U.S. NUCLEAR REGULATORY COMMISSION
REGION I

Report No. 70-687/89-05

Facility Name: Reactor and Hot Laboratory

Inspection Summary: Inspection on December 19, 1989 (Inspection Report Number
70-687/89-05)

Figure 1. Sampling Point Designations for Runoff Water

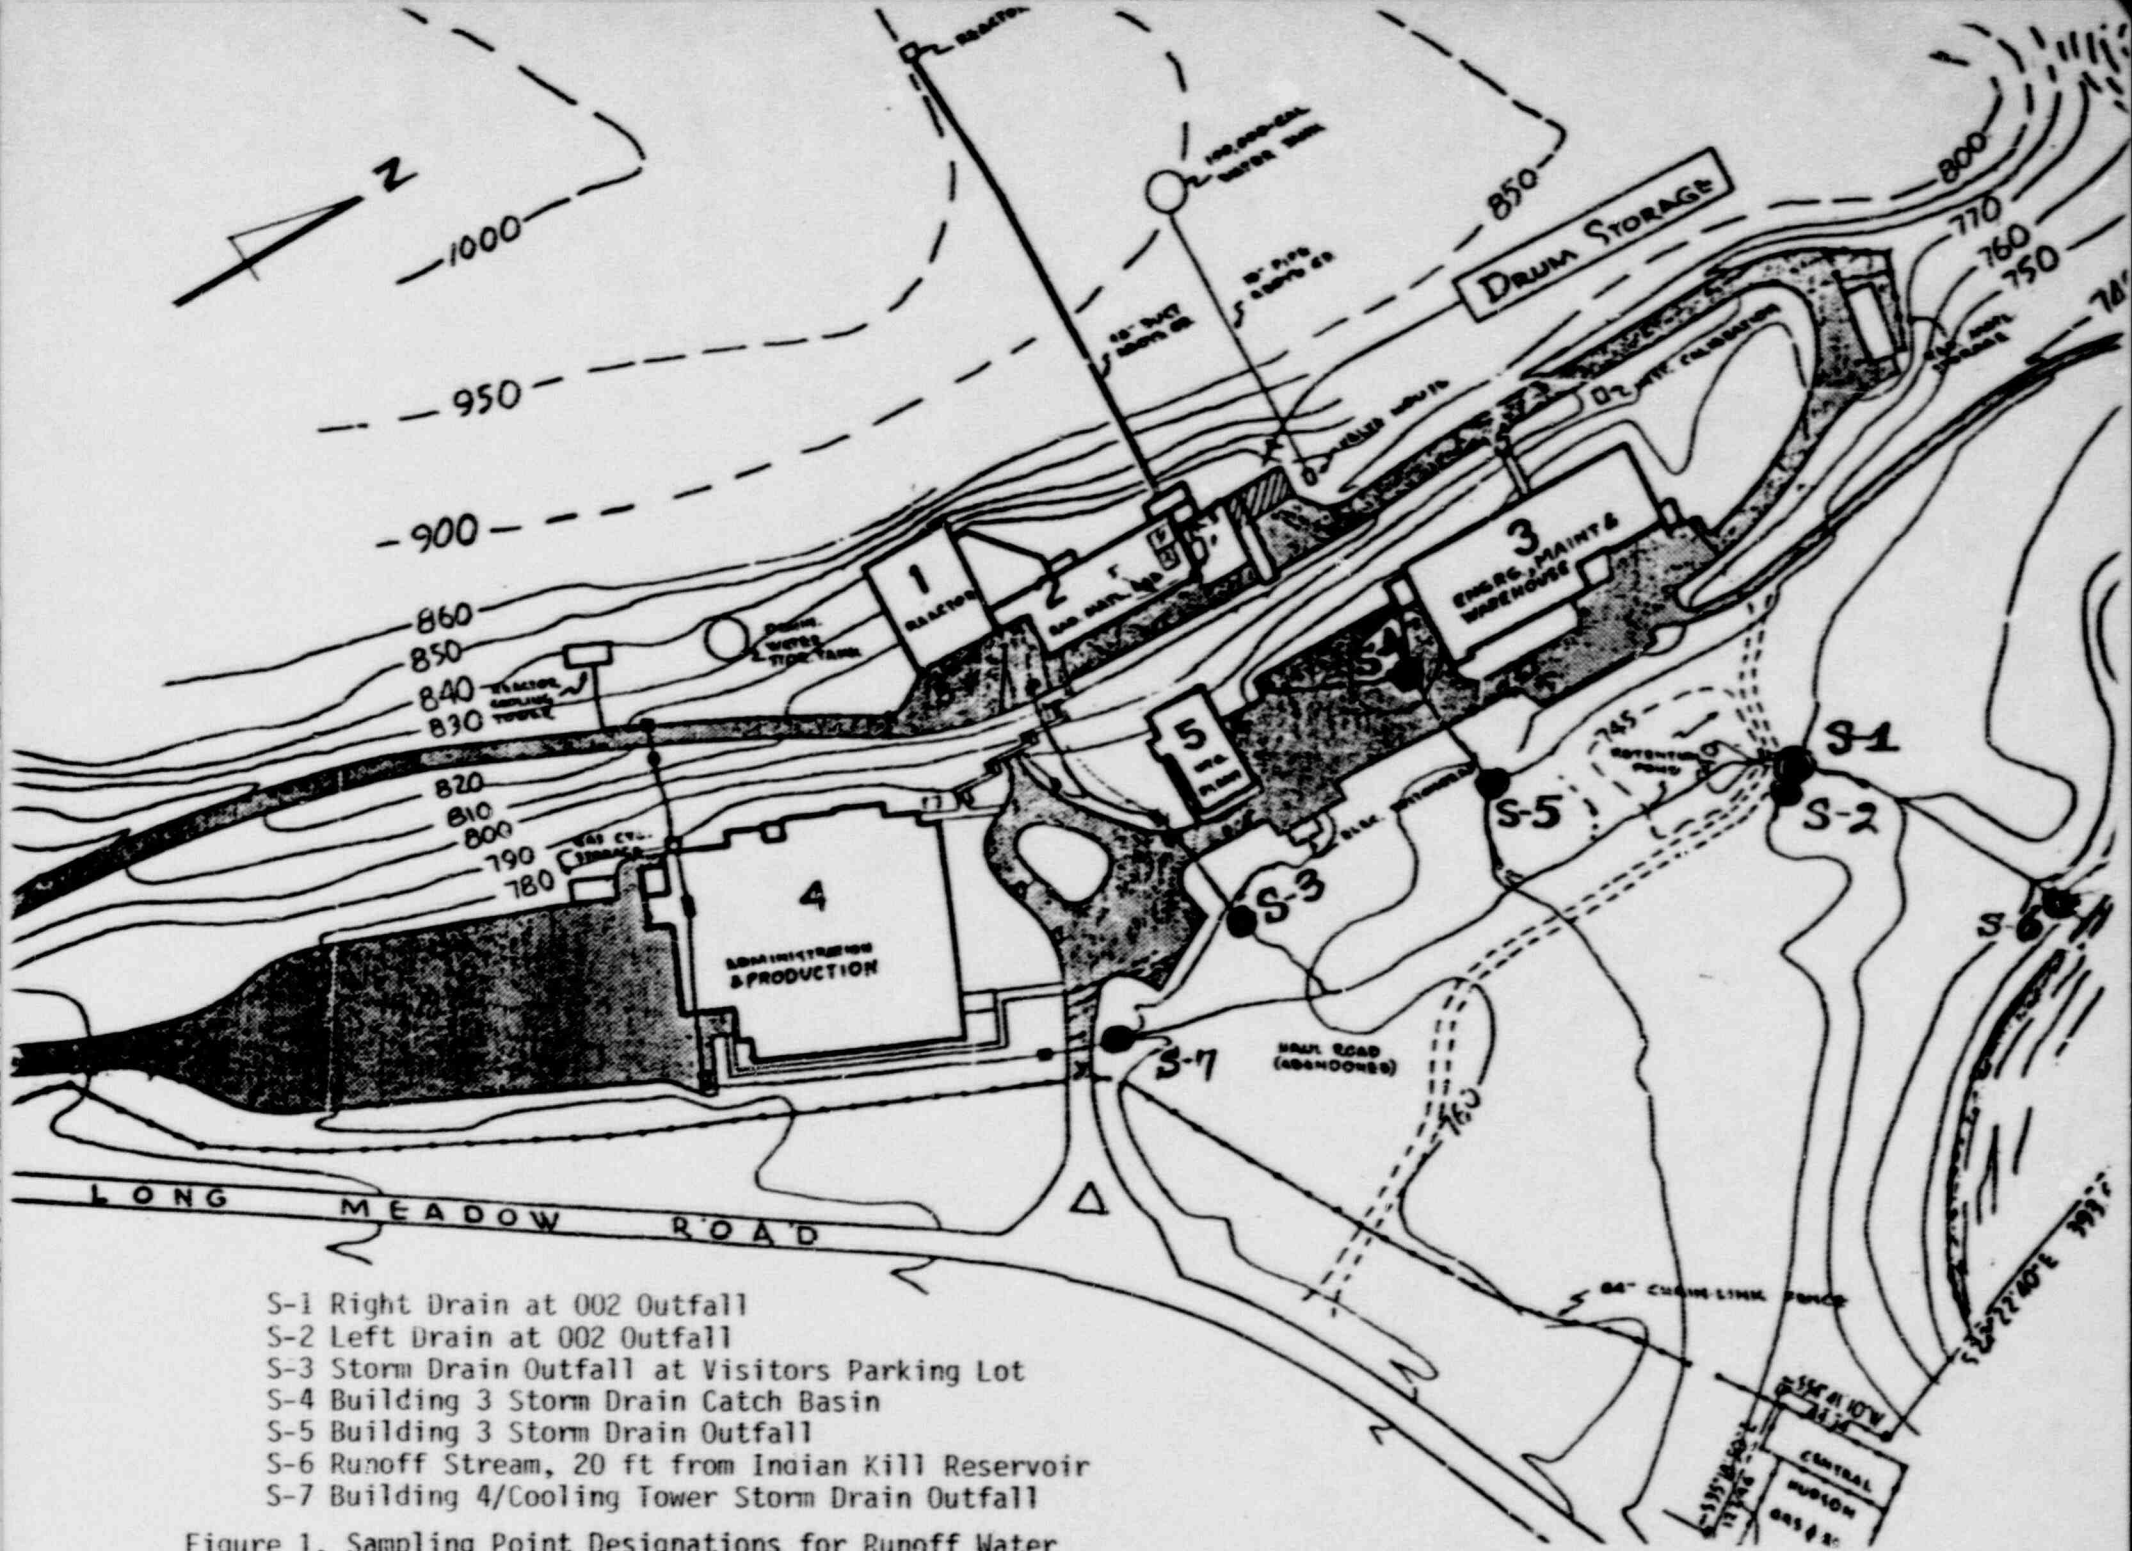
During April 1989 the licensee identified a possible discharge of slightly contaminated water through a storm drain located in the onsite parking lot (See Figure 1 for detail of sampling points). This storm drain is used to catch the runoff from (1) the parking lot, (2) Building 3 (Engineering and Maintenance Warehouse), and (3) possibly from the hot laboratory building (Building 2) area, including the roof of the building. Water collected in the storm drain discharges into a retention pond (sampling point S-5) and then flows to the Indian Kill Reservoir. The licensee identified elevated radioiodine (I-131) levels in water in the same storm drain in the parking lot (sampling point S-4) on November 28, 1989 through the routine monthly environmental surveillance program. The November 28 measurement of I-131

The licensee also measured a wet sediment sample collected from the storm drain discharge point (S-5) on December 12, 1989. The analytical result for I-131 was approximately $1.0E-6$ uCi/ml. The licensee determined that the contamination from the storm drain discharge to the retention pond was limited to an area within a 10-foot radius from the end of the discharge pipe.

The licensee also measured water samples collected from the retention pond outfall (002 Outfall, Sampling Point S-1) and the analytical results for I-131 were less than $1.0E-8$ uCi/ml. Water samples collected from the storm drain outfall at the visitors parking lot (Sampling Point S-3) indicated background levels for I-131.

Three environmental samples, one water sample and two wet soil/silt samples, were collected during this inspection to perform an independent measurement in the NRC Region I Laboratory. The water sample collected at the storm drain (sampling point S-4) was split among the licensee, representatives of New York State, and the NRC. The flow rate of the storm drain water at the sampling time was approximately 0.6 gallons per minute. Wet soil/silt samples at the outfall of the storm drain in a retention pond (sampling point S-5), and outfall of the retention pond (sampling point S-1), were collected by the NRC for analysis of iodines and long half-life radionuclides.

An immediate telephone call was made to discuss those analytical results with the licensee on December 21, 1989. The licensee's analytical results of I-131 and I-133 were about a factor of 2 lower than the NRC's results due to the licensee's gamma counting geometry correction. The licensee is currently developing the counting geometry, therefore, analytical results will be confirmed by the contractor laboratory. The presence of Mo-99/Tc-99m was also confirmed in this storm drain water sample by the licensee and the NRC. This suggests that a leakage pathway other than the ventilation system may be involved. The licensee initiated actions to investigate other possible pathways including leakage from the reactor water, reactor water transfer pool, and liquid radwaste transfer pipes. The licensee also increased sampling frequency to daily at the storm drain (S-4), outfall of the storm drain (S-5), and outfall of the retention pond (S-1).
